# HISTORIC AND DESIGN REVIEW COMMISSION

June 01, 2022

**HDRC CASE NO:** 2022-295  
**ADDRESS:** 121 CITY ST  
**LEGAL DESCRIPTION:** NCB 971 BLK 5 LOT 11  
**ZONING:** RM-4, H  
**CITY COUNCIL DIST.:** 1  
**DISTRICT:** King William Historic District  
**LANDMARK:** Individual Landmark  
**APPLICANT:** Walter Giordano/fine patio design  
**OWNER:** JANSSEN JOEL L & LATICIA  
**TYPE OF WORK:** Rear patio construction  
**APPLICATION RECEIVED:** May 05, 2022  
**60-DAY REVIEW:** Not applicable due to City Council Emergency Orders  
**CASE MANAGER:** Claudia Espinosa

Patio cover 16 X 27

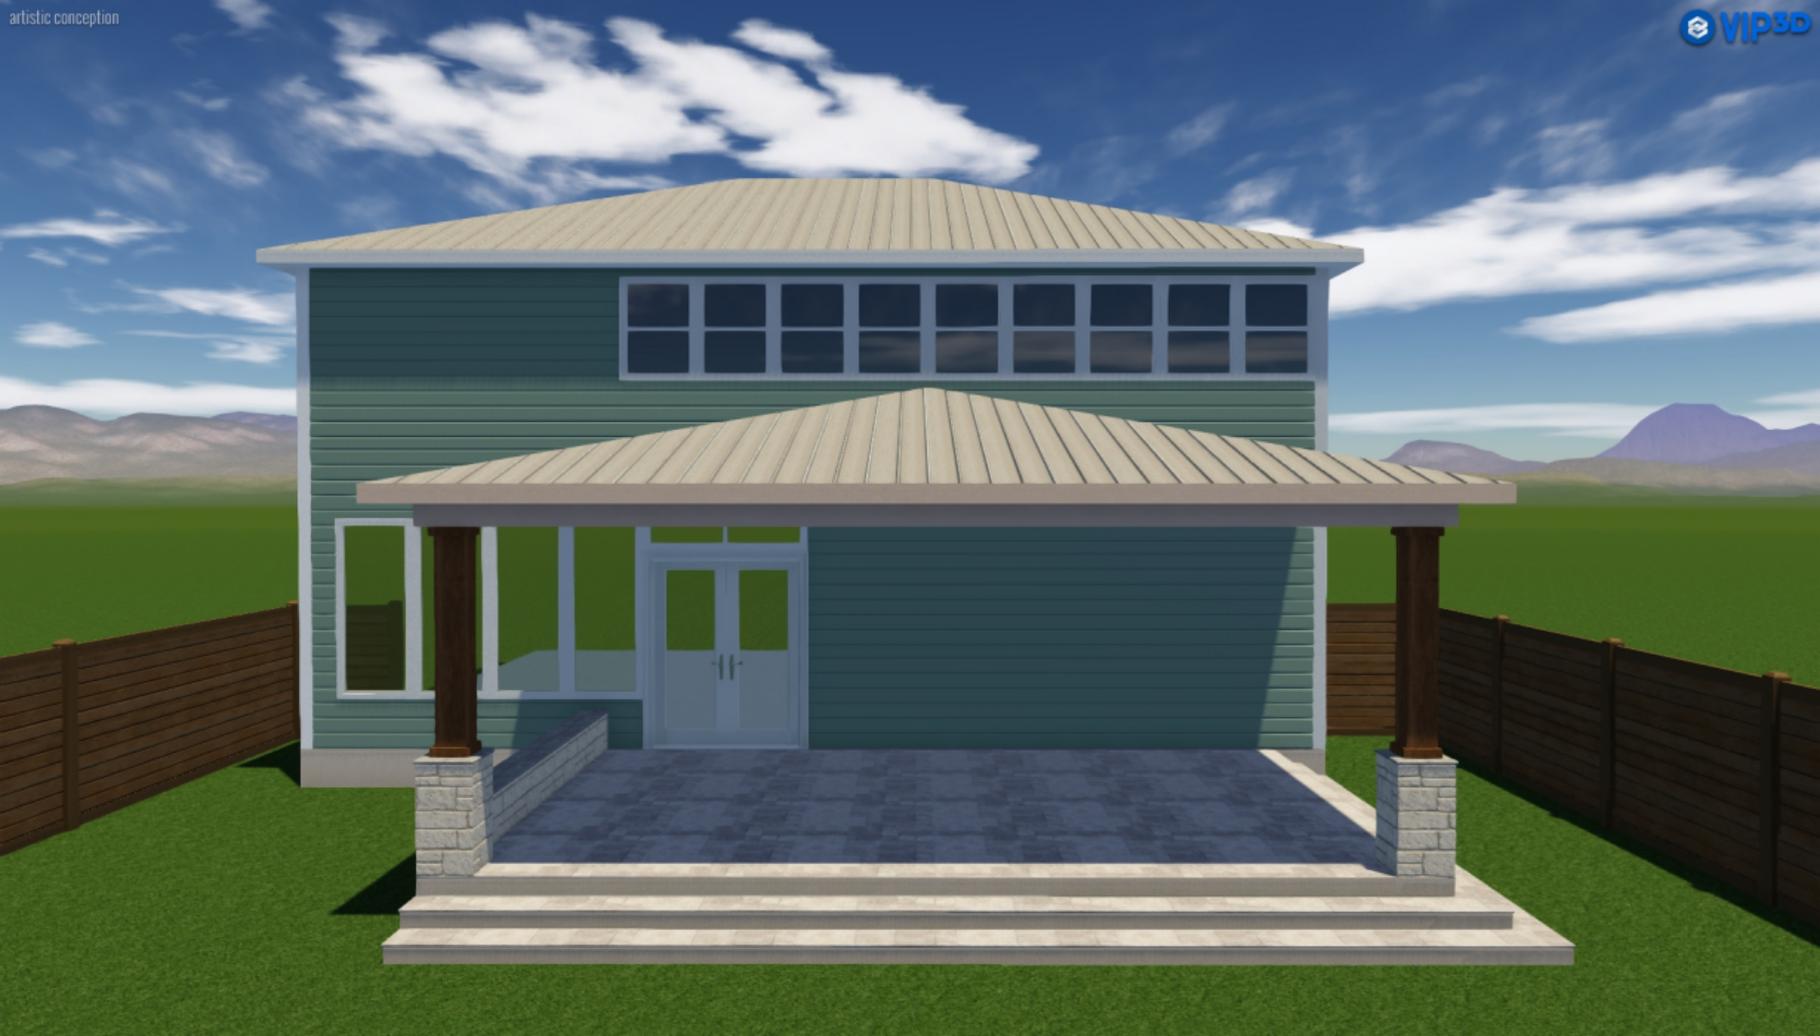
- d. MATERIALS – The applicant has proposed for the rear patio to feature cedar columns with stone bases, a concrete foundation and a standing seam metal roof. Staff finds that the cedar columns should be painted to match those of the primary structure, and that the stone bases should be amended for wood. The standing seam metal roof should feature panels that are 18 to 21 inches wide, seams that are 1 to 2 inches in height, a crimped ridge seam and a standard galvalume finish. Panels should be smooth and not feature corrugation or striations. A ridge cap with no end cap or a ridge sleeve should be submitted to OHP staff for review and approval.

- i. That the columns be painted to match the columns of the historic structure and that the stone column bases be modified for wood or brick.
- ii. That the roof feature panels that are 18 to 21 inches wide, seams that are 1 to 2 inches in height, a crimped ridge seam and a standard galvalume finish. Panels should be smooth and not feature corrugation or striations. A ridge cap with no end cap or a ridge sleeve should be submitted to OHP staff for review and approval.
